PZ-2025-5  
PDD Request  
6612 and 6618 Sawyer Road

Susana Huerta  
Planning and Zoning Director  
City Council Meeting  
April 15, 2025

E STOP GROUP, LP - 6612 and 6618 SAWYER RD – PDD PROJECT PLAN (Rev.3)

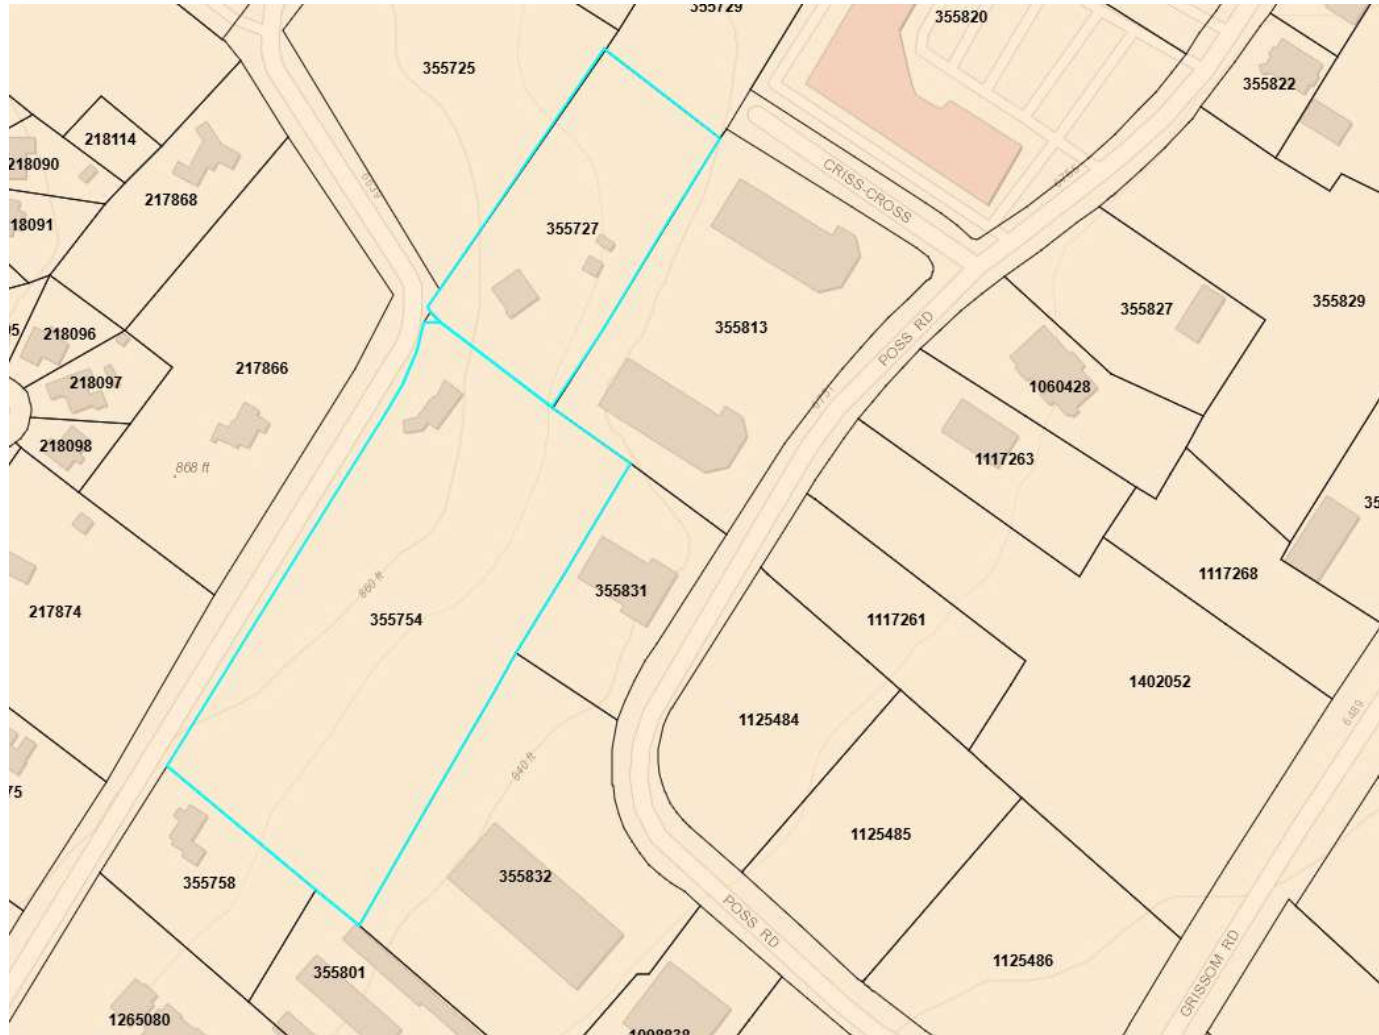
- Staff recommends the following be removed from PDD request

- Staff recommends the following be removed from PDD request

B. The Applicant shall be granted the right to modify the Site Plan so long as the required modifications to the Code, if any, are fully consistent with those required for the Site Plan as shown in Exhibit B.
